ARBORICULTURAL REPORT ADDENDUM

SECTION 73 VARIATION OF CONDITIONS APPLICATION RELATING TO THE TREE
PROTECTION MEASURES APPROVED UNDER PLANNING CONSENT REF: DC/25/0944

MERRYHILL MUSHROOMS
MERRYHILL
STORRINGTON ROAD
THAKEHAM
RH20 3ED

Proposal: Variation of Condition 3 of planning consent Ref. DC/25/0944 to permit the installation of services via trenching.

Figure 1 – Annotated planning showing route of proposed service trench

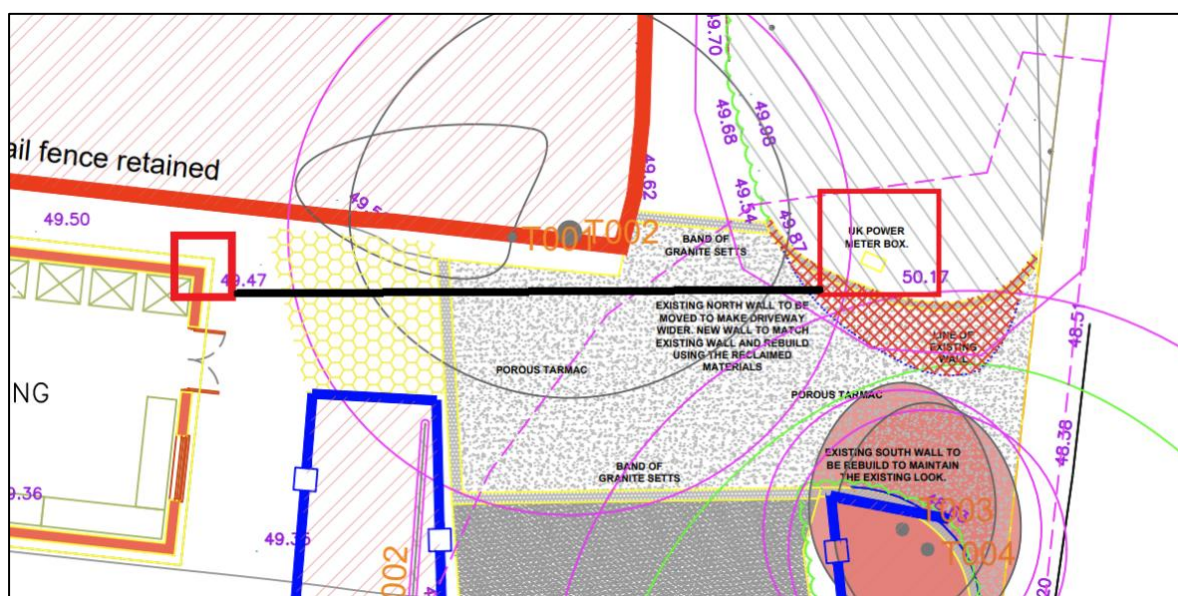
Since planning consent was granted, it has been confirmed that the only practicable route for services to the new barn is via trenching along the existing access to a Power Meter Box which is shared with the other buildings at Merryhill.

The route of the service run has been agreed in consultation with the Arboricultural Consultant. The aim of the route is to keep any excavation as far as is reasonably possible outside of the circular BS:5837 root protection area (RPA) of T005 – a high-quality category 'A' Oak tree growing at the front of the site.

To create adequate clearance to T005 (Oak), the trench will be routed closer to low-grade trees (T001 (Oak) & T002 (Sycamore)). The proximity of the trench to T001 (Oak) & T002 (Sycamore) means that woody roots and smaller fibrous roots from these trees will be present in greater numbers, therefore a hand dug trench is not a practical option.

The decision has therefore been made to remove the lower quality trees to allow for practical open trenching whilst permitting greater protection for the higher quality Oak (T005) which is to be retained.
